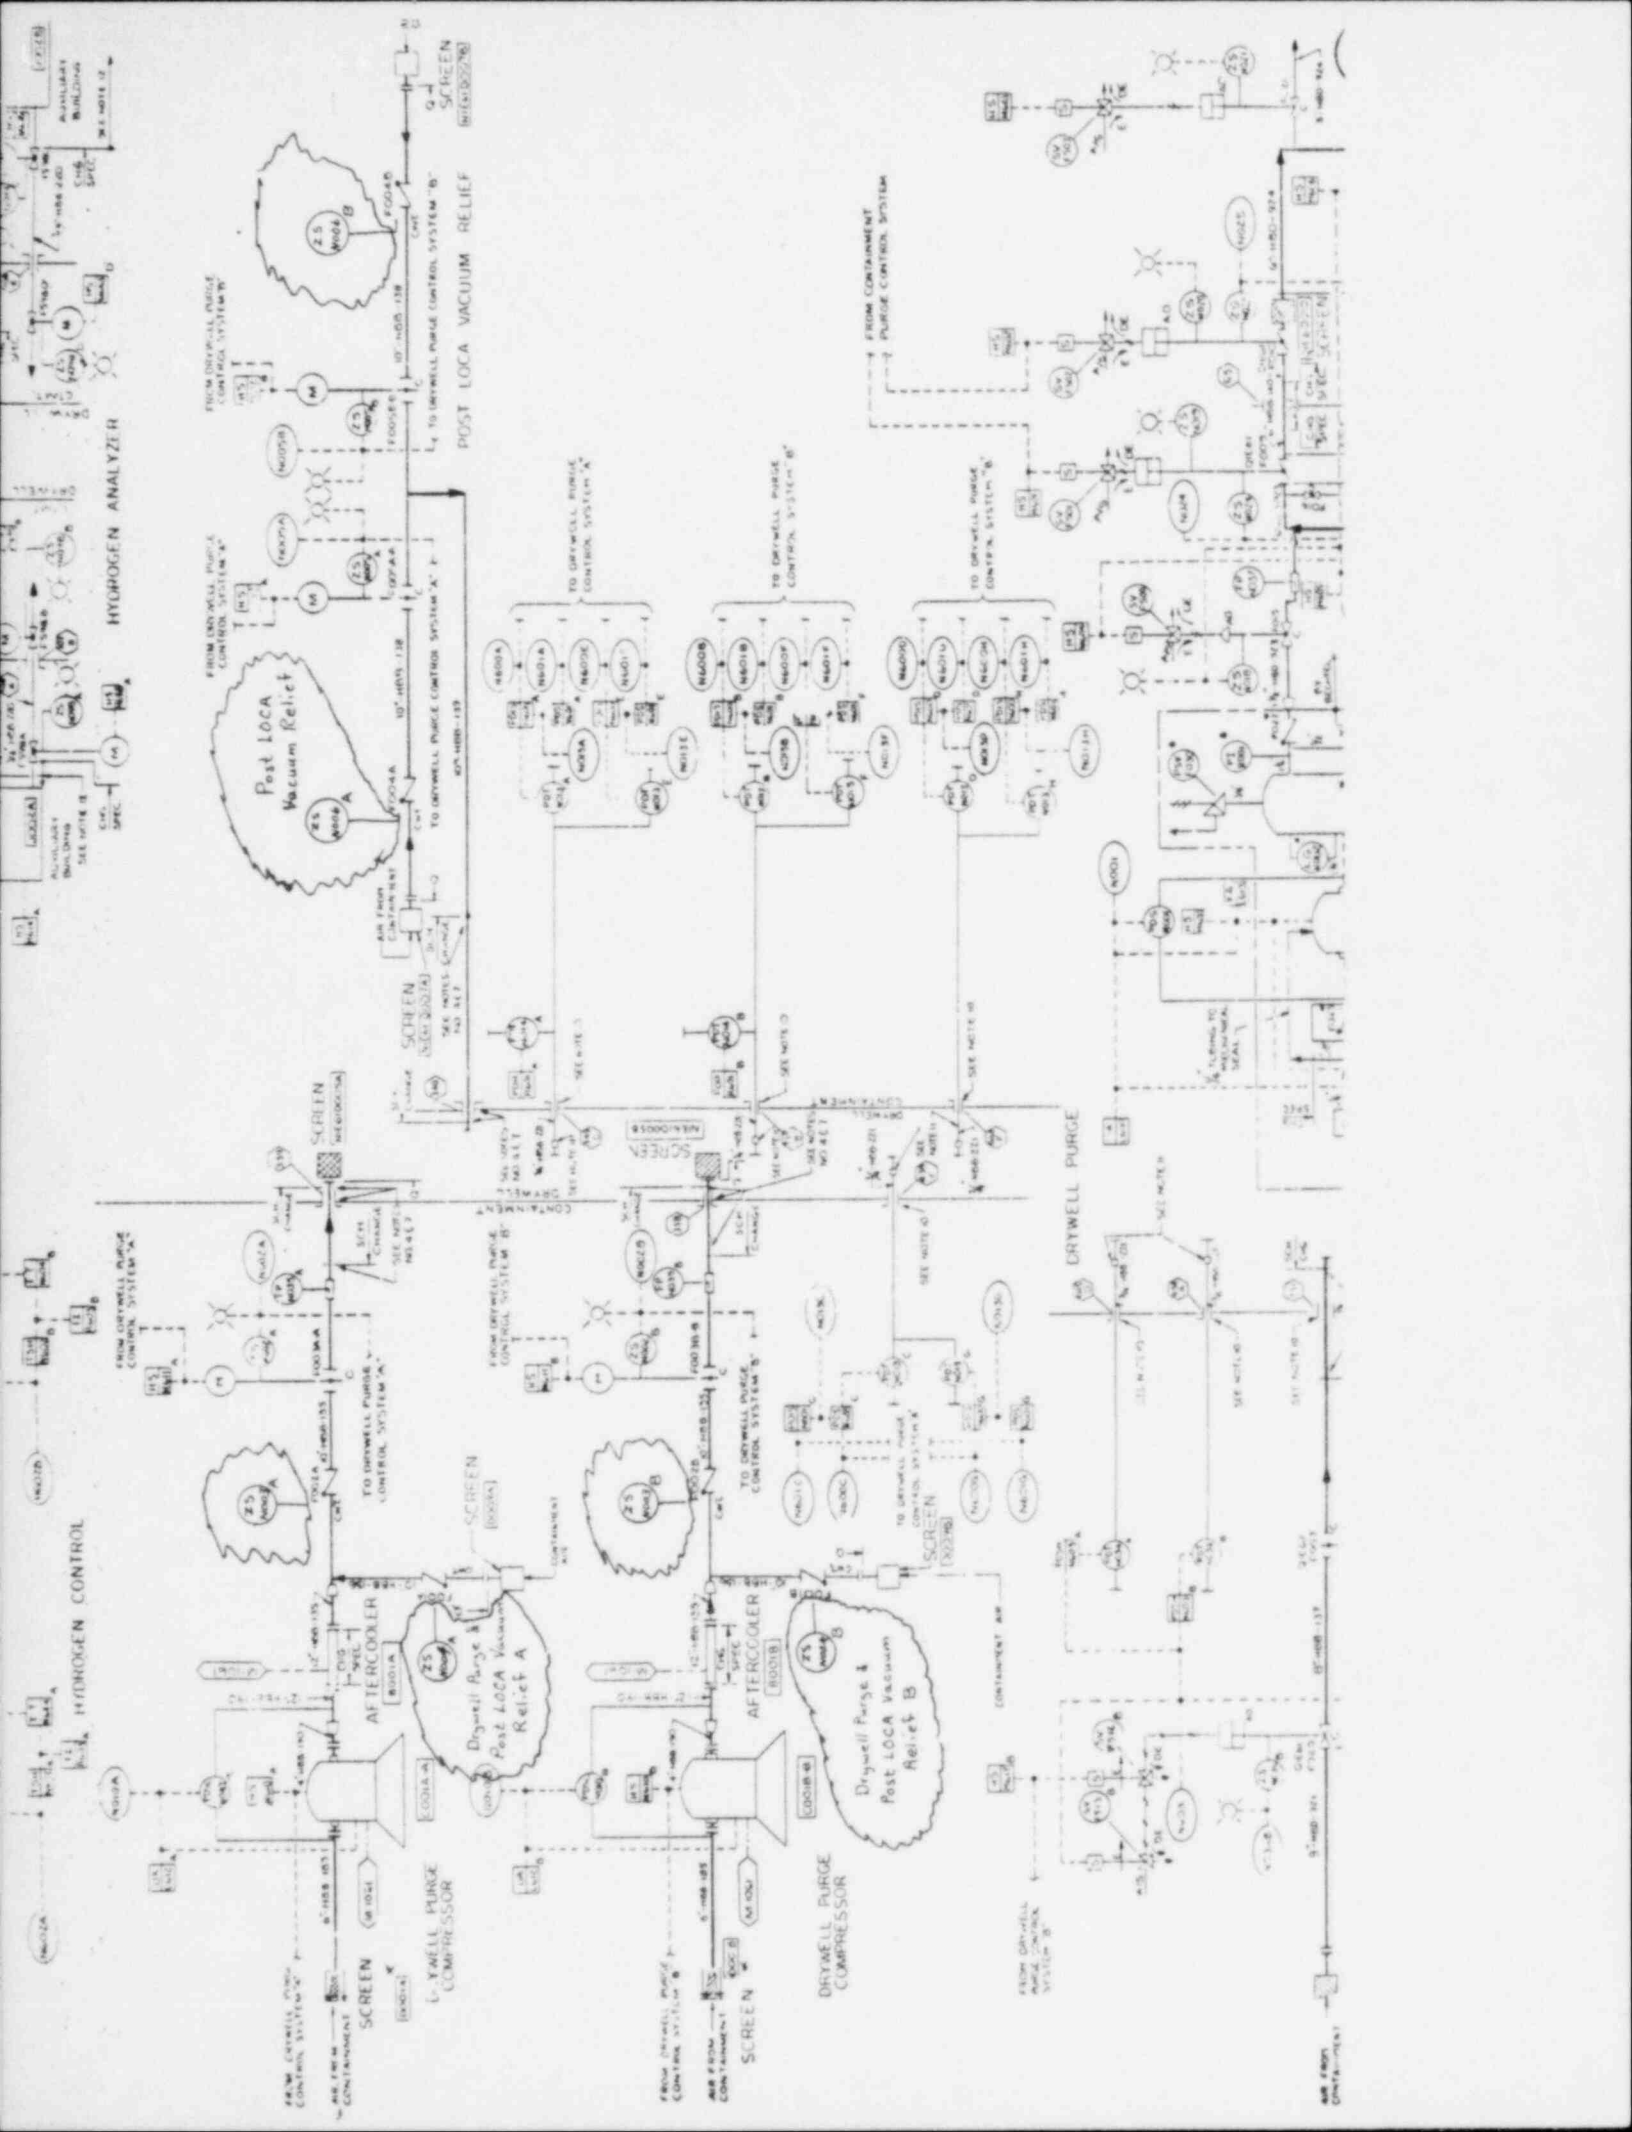
MP&L is now in the process of developing a design change to satisfy the license condition. Technical specification changes are needed to supplement this design change. It is proposed to revise the subject technical specifications by deleting the temporary and 31 day surveillance requirements on the Drywell Post-LOCA Vacuum Breakers.

On May 24, 1985, in a letter to Mr. Harold R. Denton from Mr. O. D. Kingsley, MP&L described proposed changes to add single proximity type indicator switches (see attached drawing) to the vacuum breaker check valves. Separate position indication for each of the six check valves would be provided in the control room with a single common

annunciator alarm. The redundancy of position indication as required by the license condition would be met (1) between the vacuum relief lines by providing single switches on redundant check valves (i.e., F004 A and F004 B) and (2) within the vacuum relief lines by providing check valve and MOV isolation valve position indication (i.e., F004 A and F005 A) in each line.

The proposed change will delete the surveillance requirements placed in the Unit 1 technical specifications by Amendment No. 4 to NPF-13. The proposed change will also delete the 31 day surveillance requirements for the Drywell Post-LOCA vacuum breakers. Section XI of the ASME Boiler and Pressure Vessel Code for inservice pump and valve test procedures provides the rules and requirements for testing to verify operational readiness of valves (and their actuating and position indicating systems) in light-water cooled nuclear power plants. Section XI of the ASME code requires that the valves associated with the Post-LOCA Vacuum Breaker System be exercised at least once every 3 months unless such operation is not practical during plant operation. MP&L has been unable to determine the bases for the present 31 day surveillance interval in the technical specifications, however, MP&L believes that the 3 month test program as stated in Section XI of the ASME code is adequate to ensure safe and reliable valve operation during a postulated LOCA. In order to eliminate the need to revise plant procedures which reference the surveillance requirements of 4.6.5.b, MP&L proposes that the remaining requirements of 4.6.5.b not be renumbered, but that 4.6.5.b.1 be "DELETED."

Figure 1

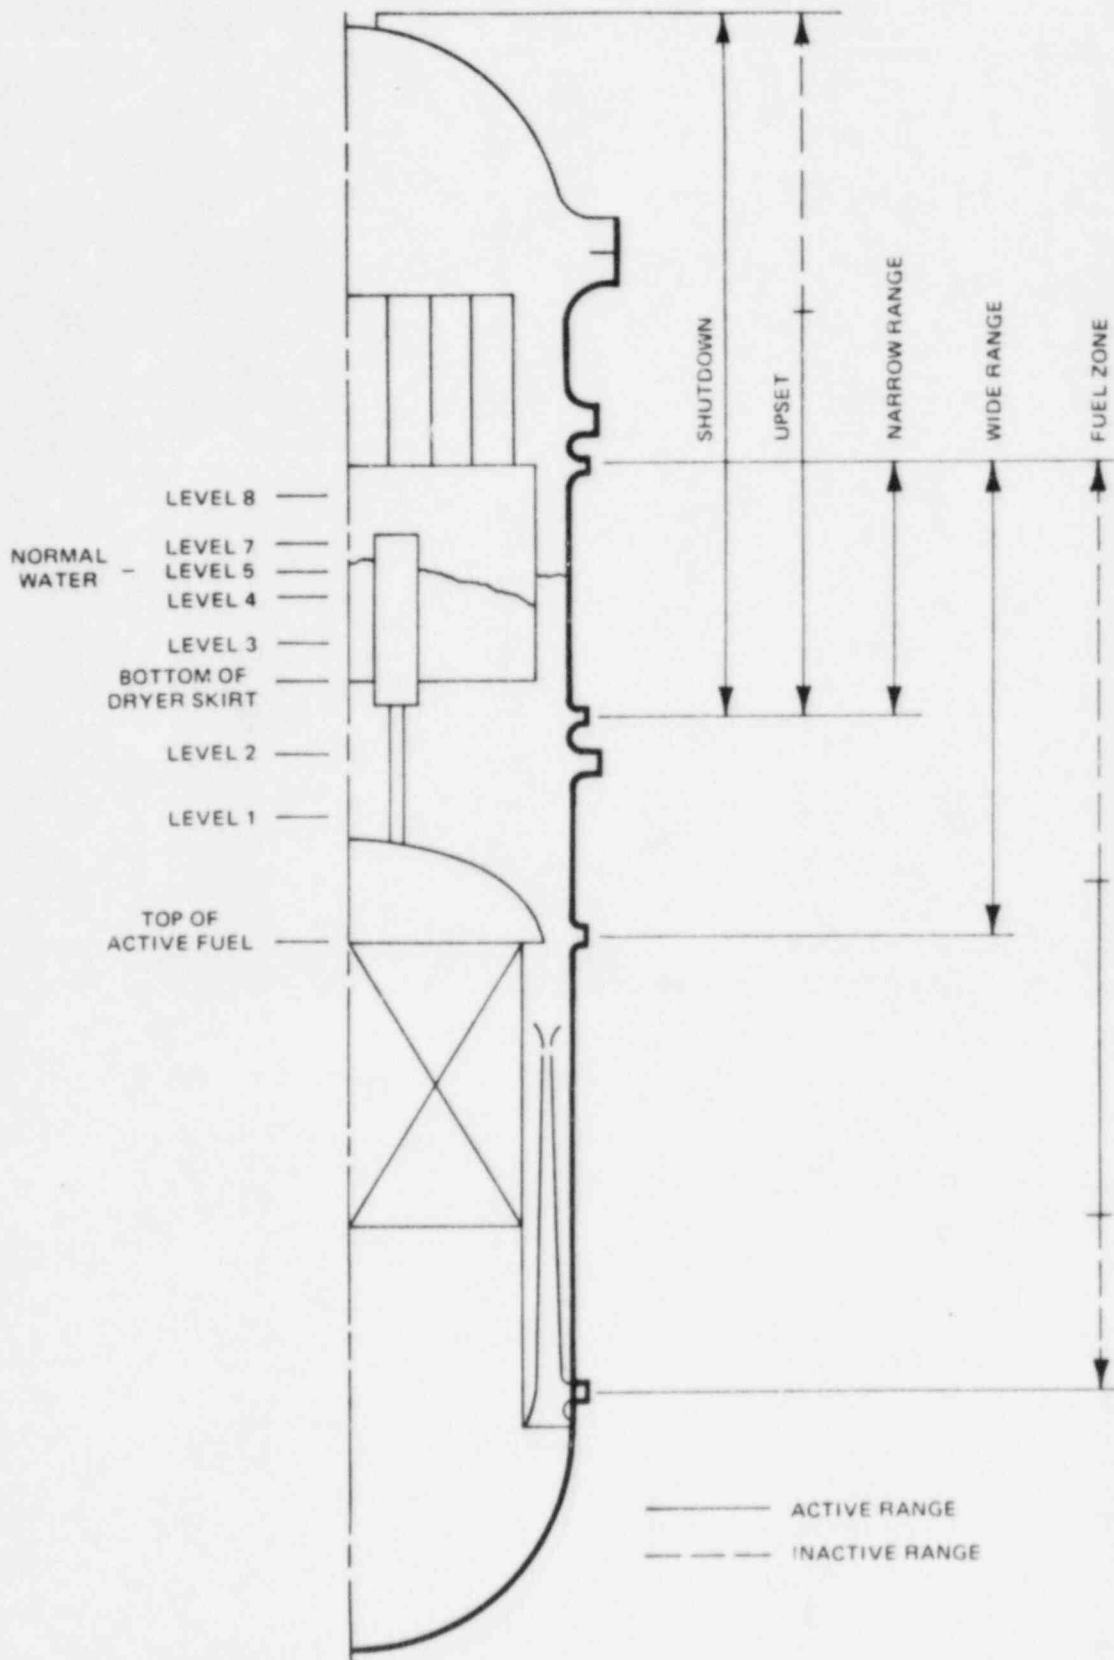
Reactor vessel water level is monitored by level transmitters that sense the difference between the pressure due to a constant reference leg of water and the pressure due to the actual height of water in the vessel. The instrumentation is the condensate chamber reference leg type (See Figure 1.) These instruments are strictly differential pressure devices which are reactor coolant density sensitive and are calibrated to be most accurate at the specific vessel conditions appropriate for the associated system functions actuated by the instrumentation.

Deletion of the phrase "Prior to STARTUP following the first refueling outage" modifies the ## notes such that the requirements remain applicable through the first refueling outage and are extended throughout subsequent plant operations. By imposing the requirements on subsequent plant operations, design modifications and concomitant potential problems are negated. The notes were initially added to Technical Specifications Tables 3.3.3-1 and 4.3.3.1-1 to address a concern with respect to the reactor vessel level instrumentation. The requirements were imposed through the first refueling outage which allowed adequate time to consider the necessity for a design modification. A design modification has been determined to be unnecessary because the requirements as currently imposed are considered adequate to ensure the continued safe operation of the plant. The following is a discussion of the reactor water level instrumentation and concern, which prompted the imposition of the requirements, to indicate that the concern has been properly addressed, a redesign is not required, and the subject change to the ## notes is justified.

PEAK CLADDING TEMPERATURE AND
 MAXIMUM LOCAL OXIDATION VERSUS
 BREAK AREA
 FIGURE 6.3-8

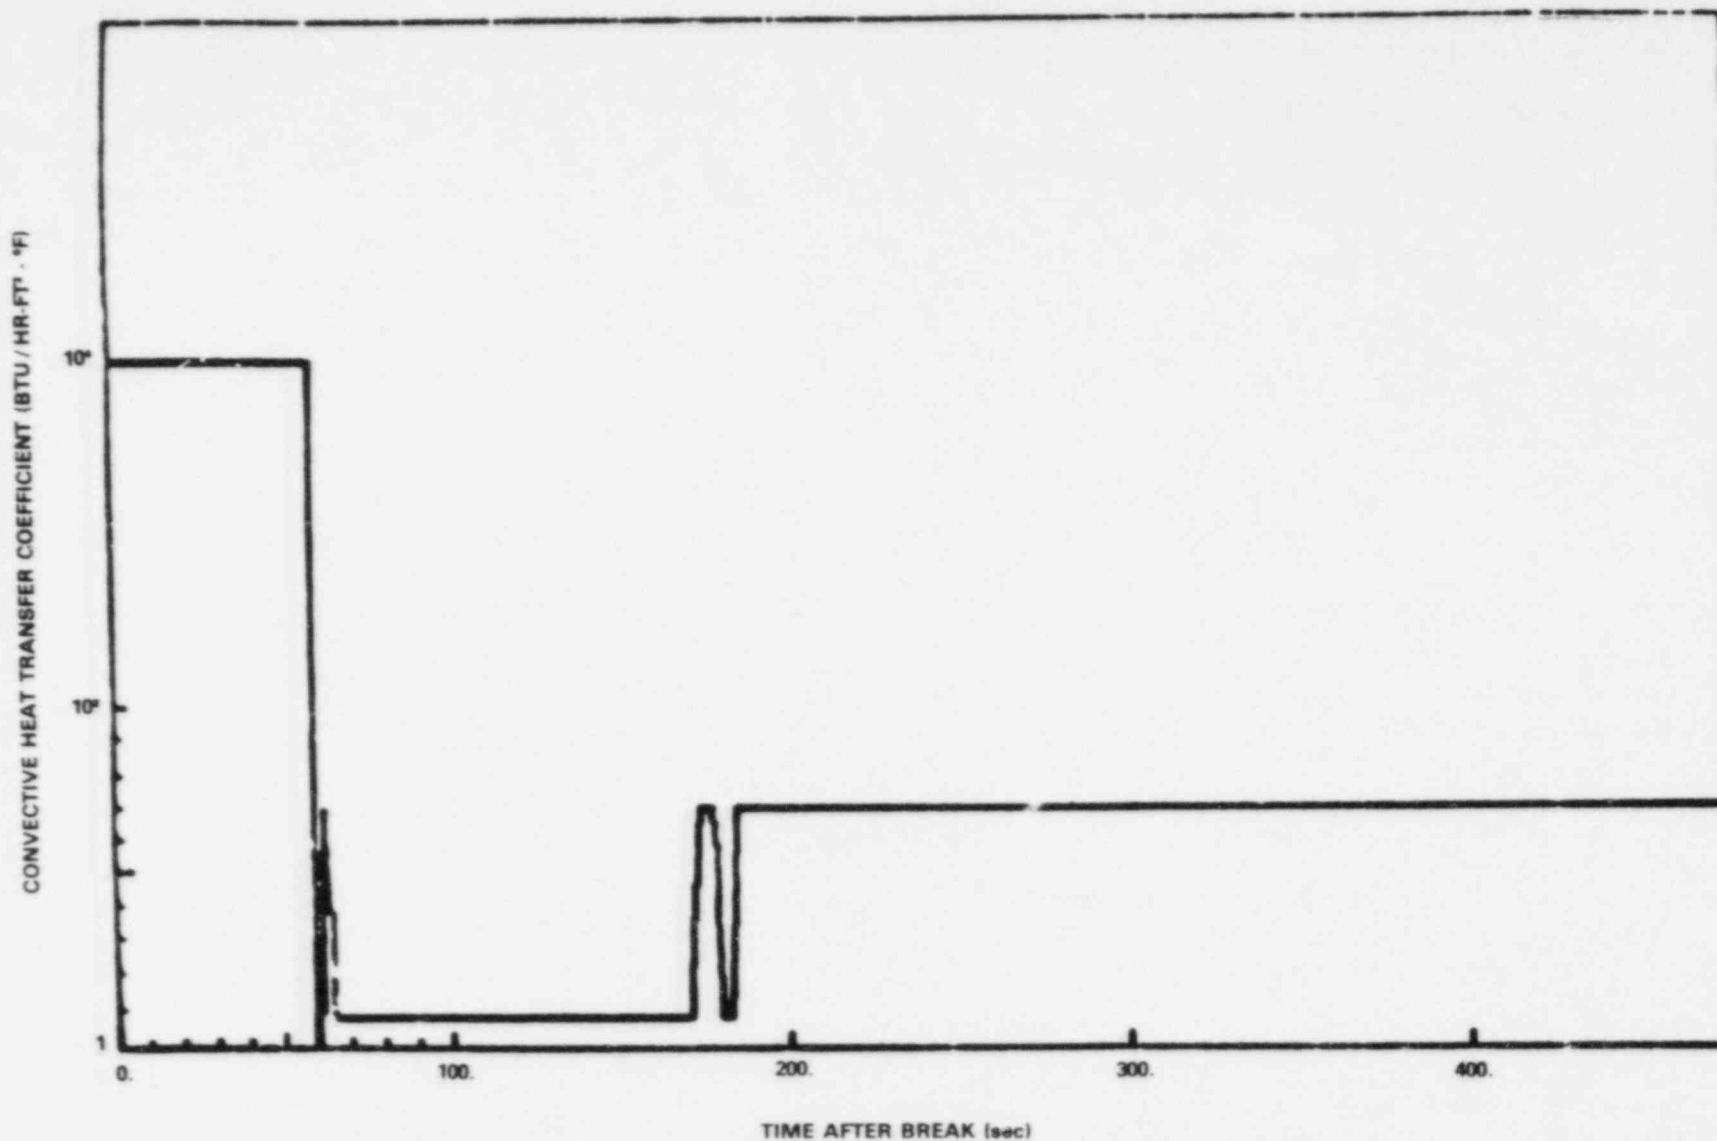
To document the effect on the LOCA analysis of this change in ECCS initiation assumptions, copies of FSAR Figures 6.3-8, and 6.3-63 through 6.3-66 are attached. These figures show the PCT versus break area, and the convective heat transfer coefficient, water level, pressure and peak cladding temperature response to this event. Appropriate FSAR updates will be made to reflect the above assumption in the discussion for the main steamline break event.

CONVECTIVE HEAT TRANSFER COEFFICIENT
VERSUS TIME AFTER PREAK STEAMLINE BREAK
(3.5 SQ. FT.), INSIDE THE CONTAINMENT,
LPCS DIESEL GENERATOR FAILURE
FIGURE 6.3-63

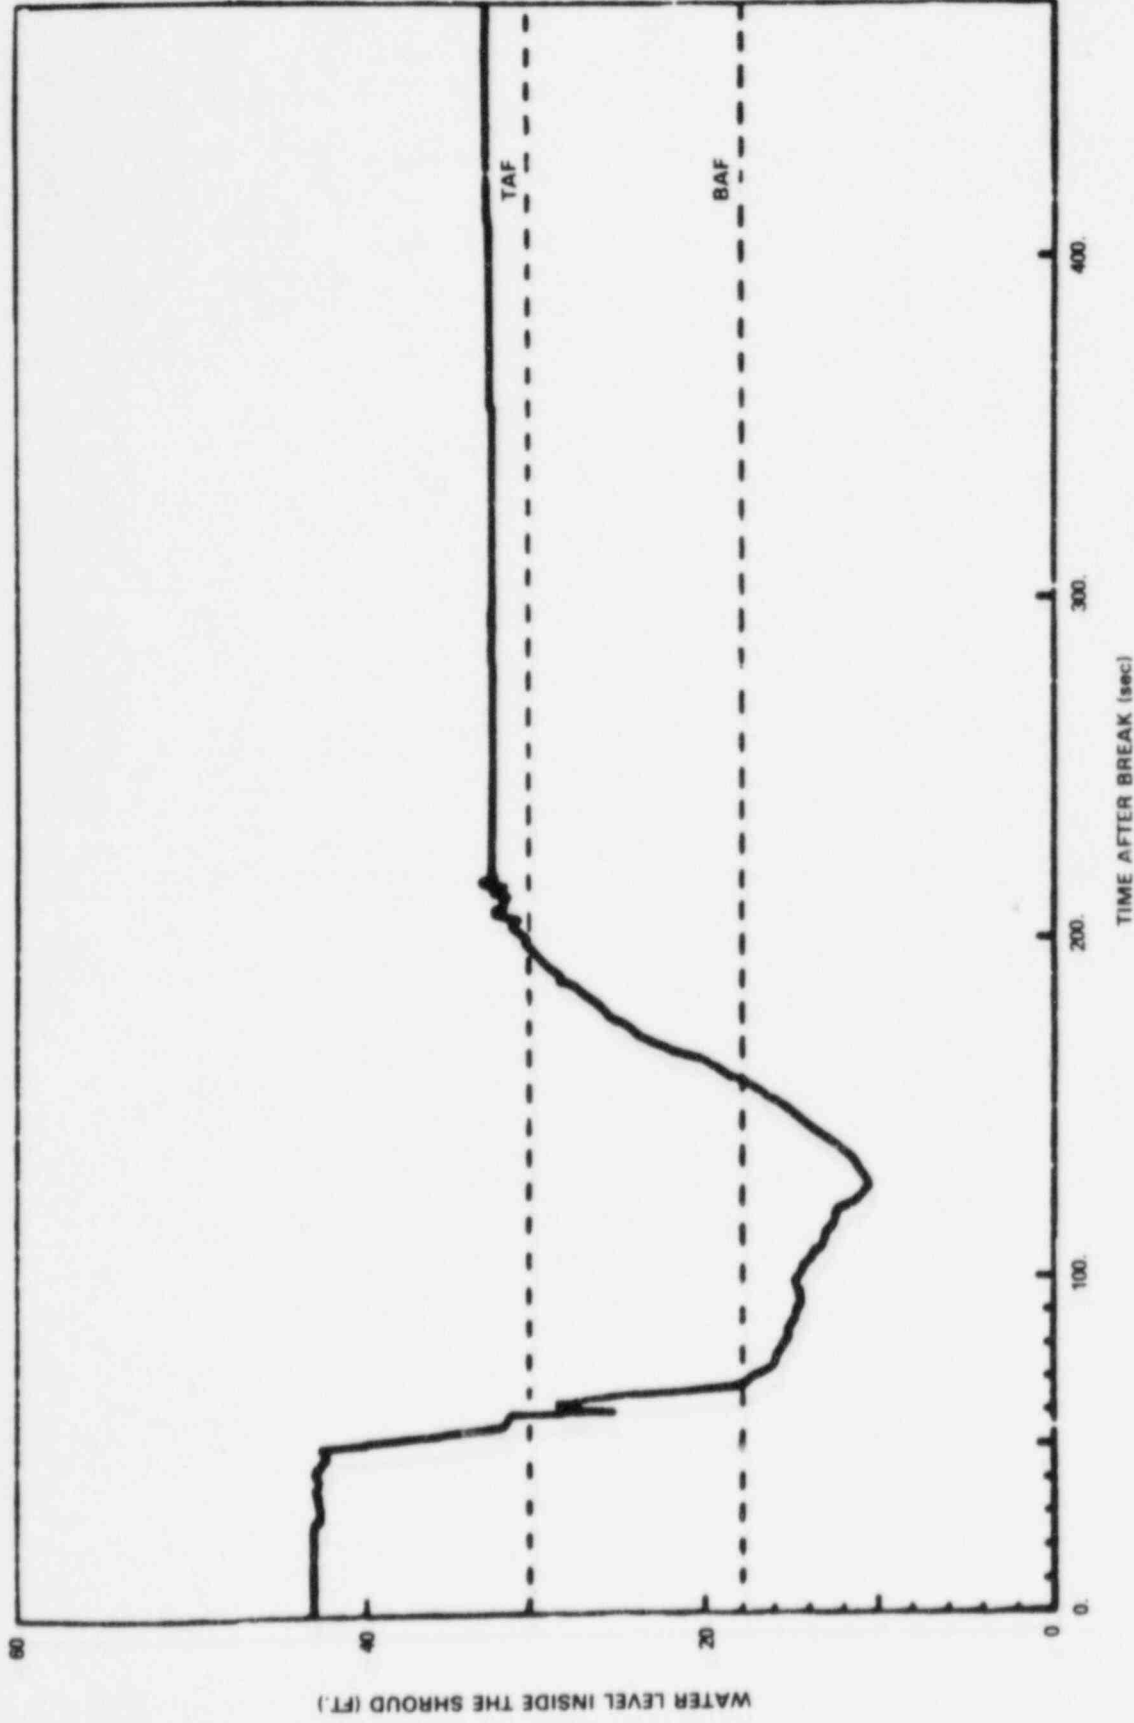
The design basis accident (DBA) steamline break inside the containment was analyzed to determine the effect of starting the ECC systems on low water level only. This event was selected because it was the only event previously in the Grand Gulf FSAR ECCS analysis which took credit for ECCS initiation on high drywell pressure.

For the previous case, the LPCI diesel generator (D/G) was the limiting failure with a calculated PCT of 934°F. The HPCS, LPCS and 1 LPCI systems were assumed to begin injecting at 27, 40 and 40 seconds respectively.
